Re: Initial Submission Review - NINE MILE APARTMENTS AT THE POINT - SITE PLAN

Application Number: **DA-2061-05**

Case Number(s): **2020-6027-00**

Initial Submission Review

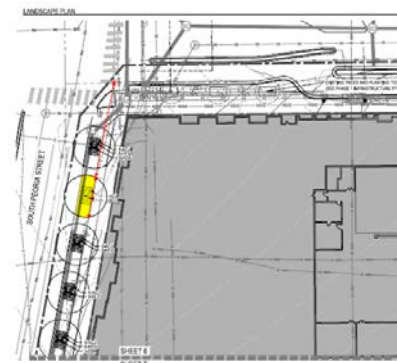
- 6D. For ground floor units, there must be articulation at entry points. Examples are provided here, we may want to discuss how to address this issue given the modern design of the building.
